# ADDENDUM NUMBER ONE
# to the
# PROJECT SPECIFICATIONS
# and
# CONTRACT DOCUMENTS
# for
# Airport Well #3 Equipping Project

**DATE OF ADDENDUM:** **August 16, 2013**

JOB NO. 8332A.10
DRAWING NO. M-03
SHEET NO. 22 OF 61

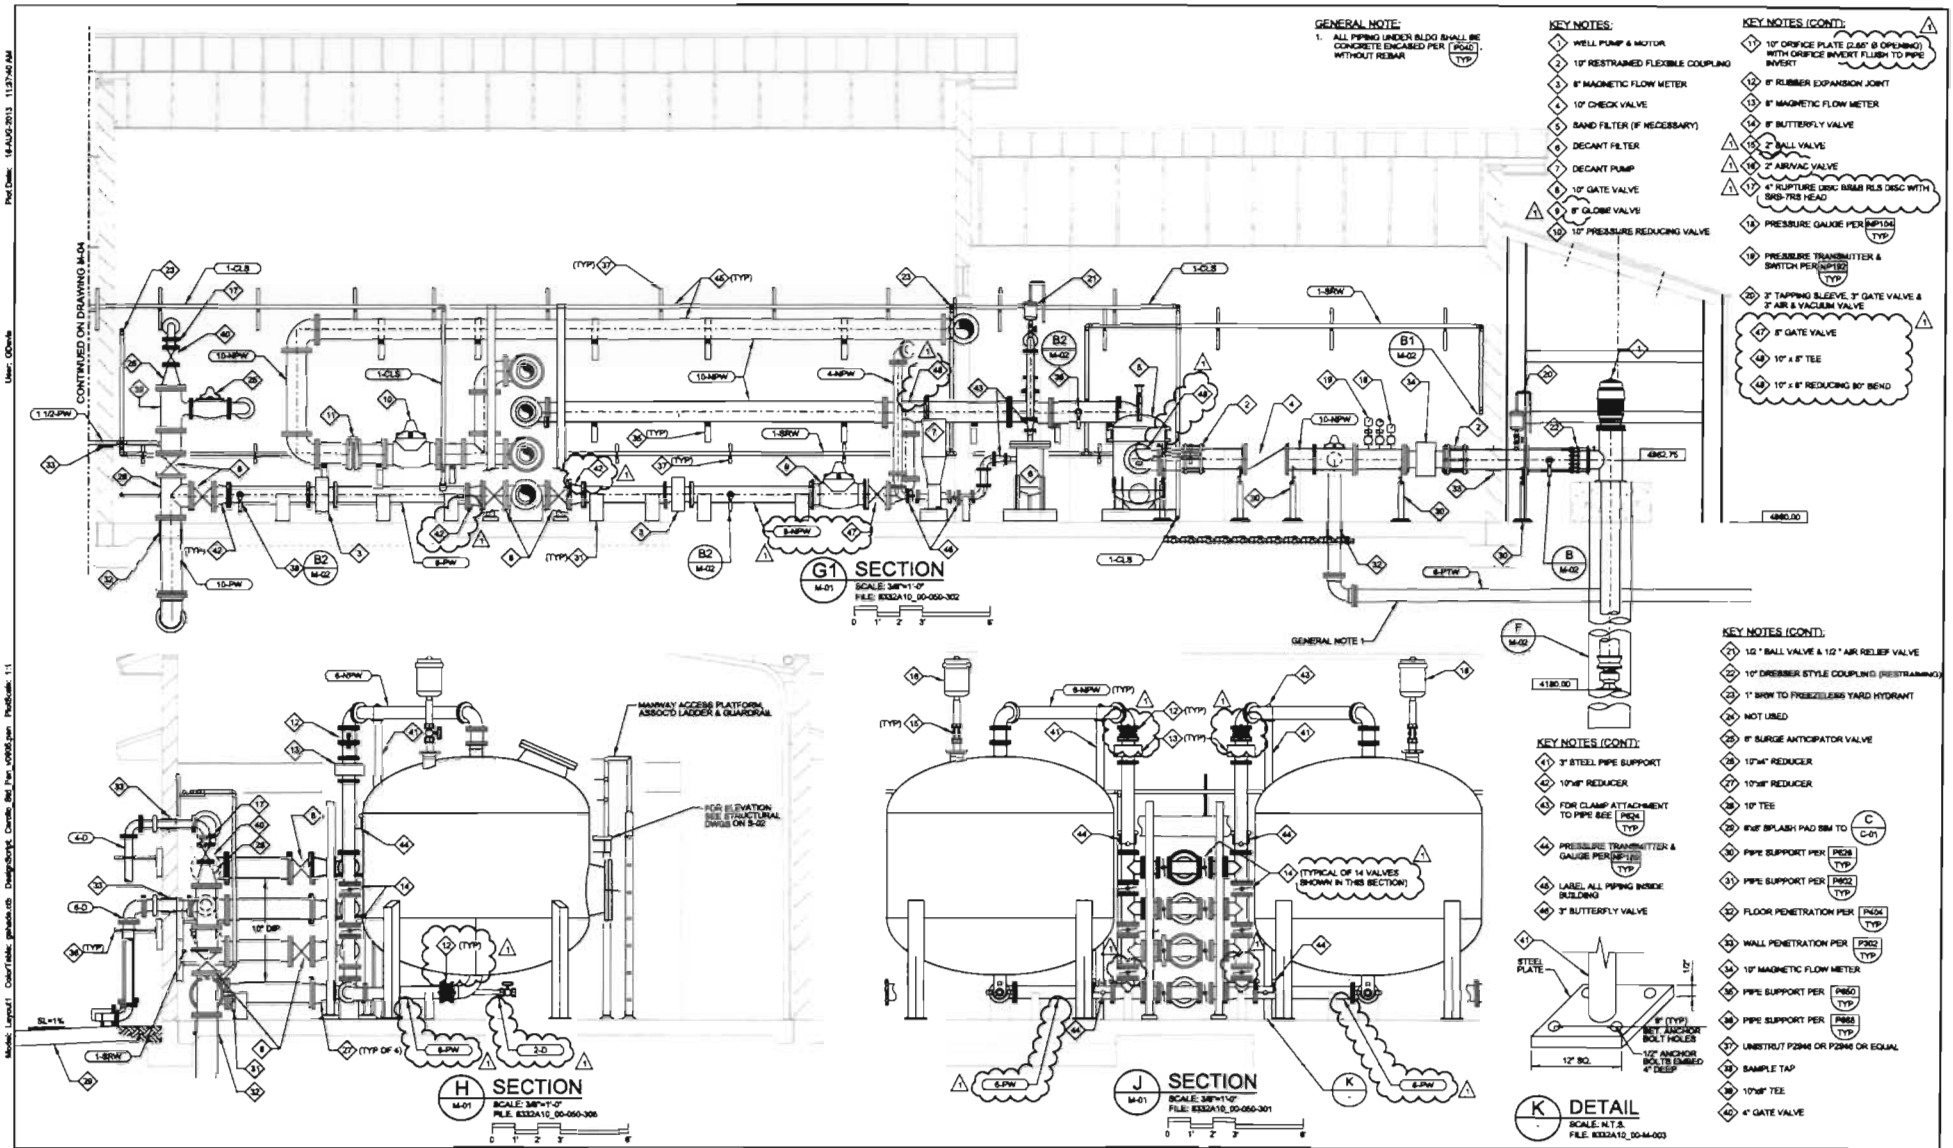
5. Drawing M-03 has been revised and is submitted as an attachment to this Addendum #1. All changes shown on Drawing M-03 have been clouded.

8. Q: Drawing M-03 key note # 9 calls for a 10" Globe Valve, I refer to spec 15115 and the specified globe valve for larger than 3" calls for Crane 351 or Lunkeheimer 1123 along with the option of Crane 212p or 384p or Lunkeheimer 72-ps or 73-psi. All of these valve are manually operated however key note #9 is drawn as an automatic type valve same as keynote #10 10" pressure reducing valve spec 15118. What is the correct spec for key note #9?

11. Q: Drawing M-03: This drawing shows there are 6 valves per vessel. Drawing N-02 shows there are 7 valves per vessel. Which is the correct number of valves per vessel that is required? STWP can perform these same functions using only 5 valves.

16. Q: Key Note 9 calls for a 10" globe valve however the picture appears to depict a pressure reducing valve similar to Key Note 10 shown elsewhere on the drawing

25. Q: Drawing M-02 Section J and H Key Note 12 calls for a 6" rubber expansion joints. However the drawing shows only a flg xflg spool with something tie them together.
    I do see on section H there is a rubber expansion joint shown on the bottom discharge piping out of the contactor vessels. There is no key note describing the type.

A: 7 valves per vessel is the design (see re-issued Drawing M-03) to allow for greater operational flexibility.

A: Key Note 10 is a 10-inch pressure reducing valve; Key Note 9 is an 8-inch globe valve that is used for flow control. Body styles could be similar based on manufacturer.

A: The rubber expansion joints have been shown and called out correctly on the updated Drawing M-03.

C120 TYP — SIDEWALK

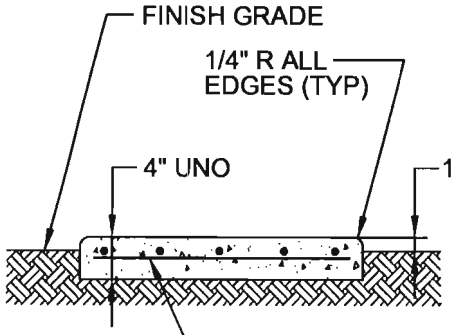
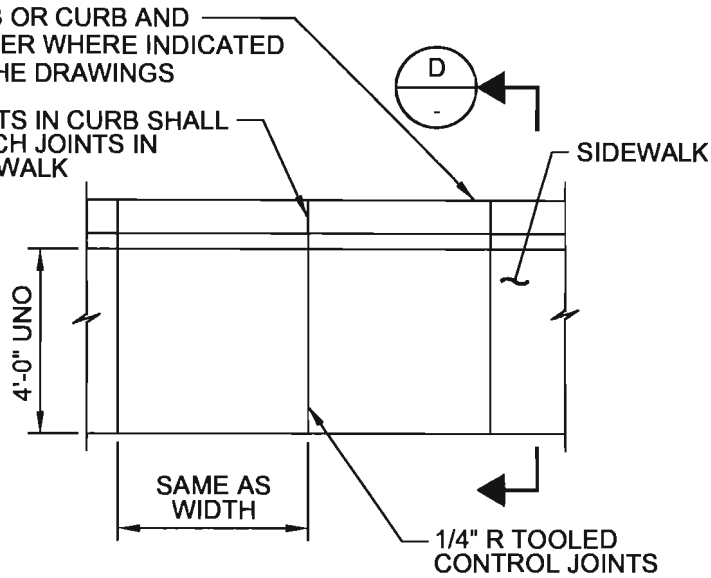
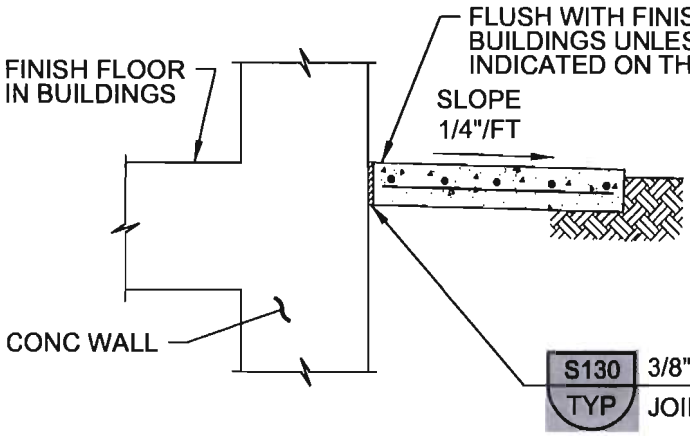
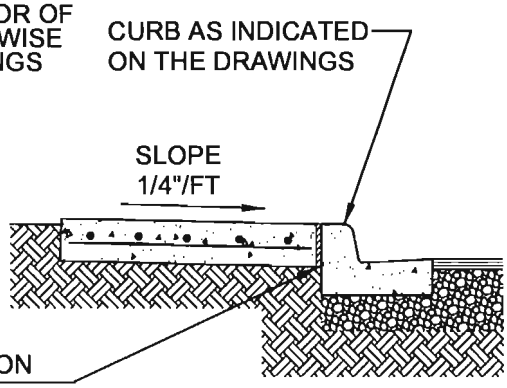
Typical Detail C120 is called out just east of the electrical room, but is not provided in the Typcial Detail Drawings. Typical Detail C120 is attached to this Addendum #1.

A801 TYP

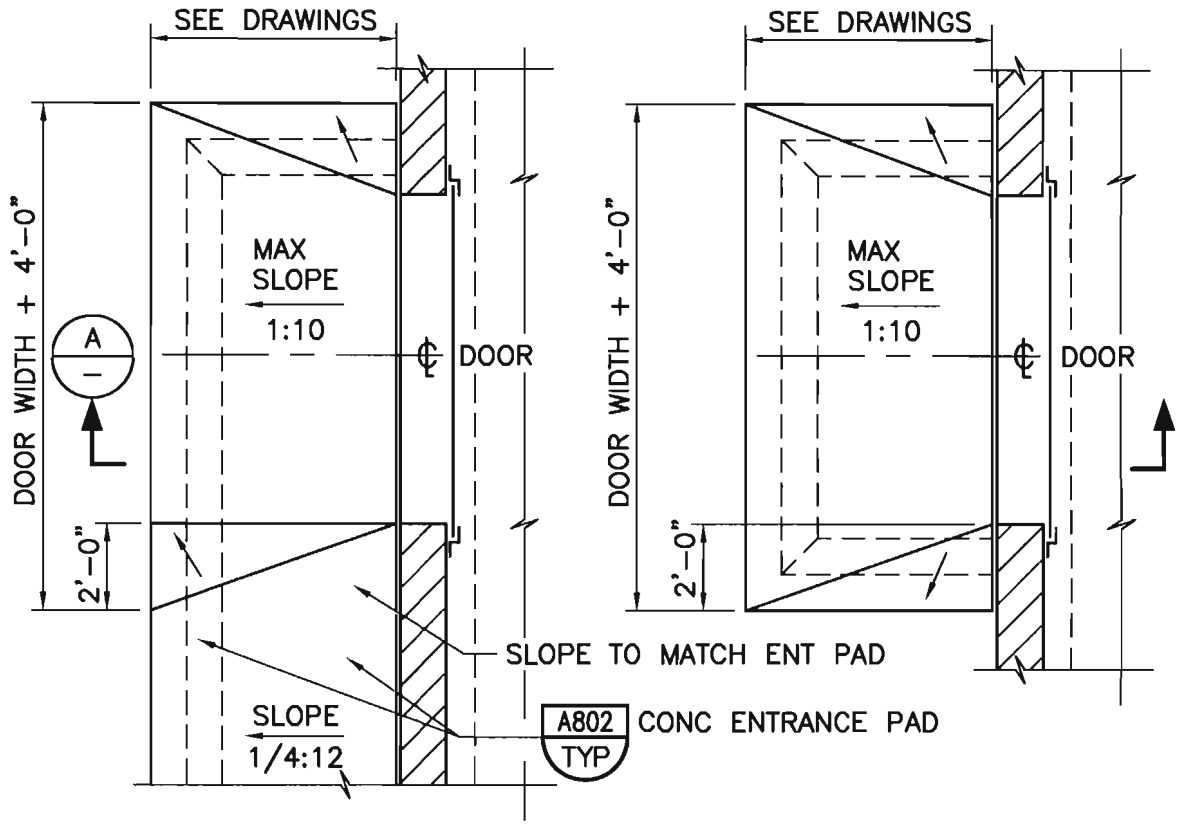
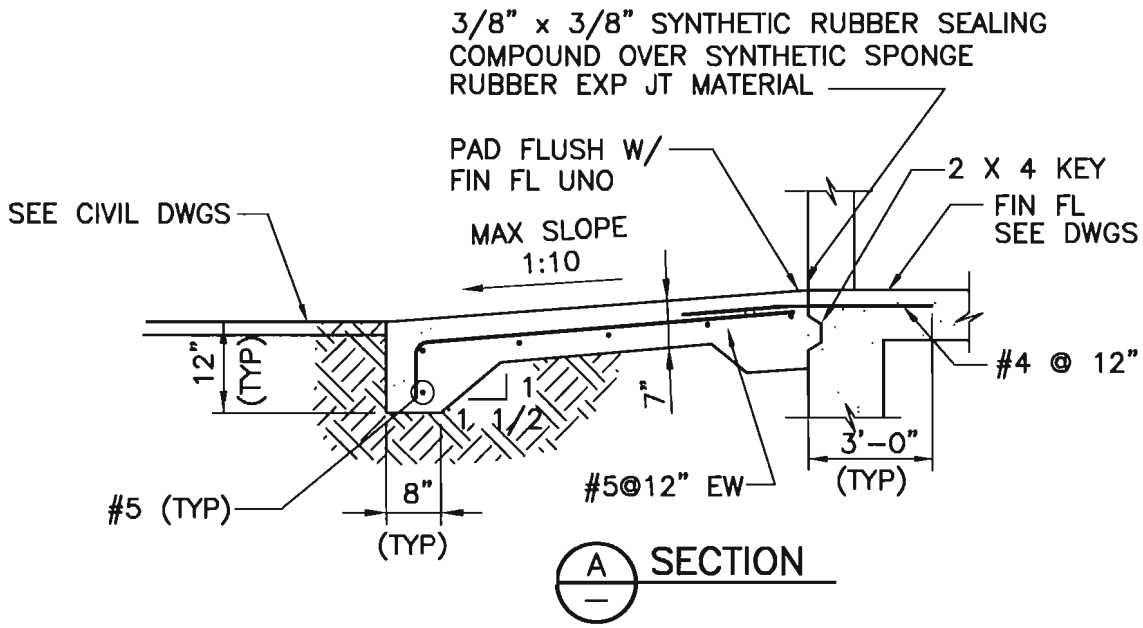
Add Typical Detail A801 to vehicle ramp callout "SEE 'A' DRAWINGS FOR DIMENSIONS AND DETAILS". Typical Detail A801 is attached to this Addendum #1.
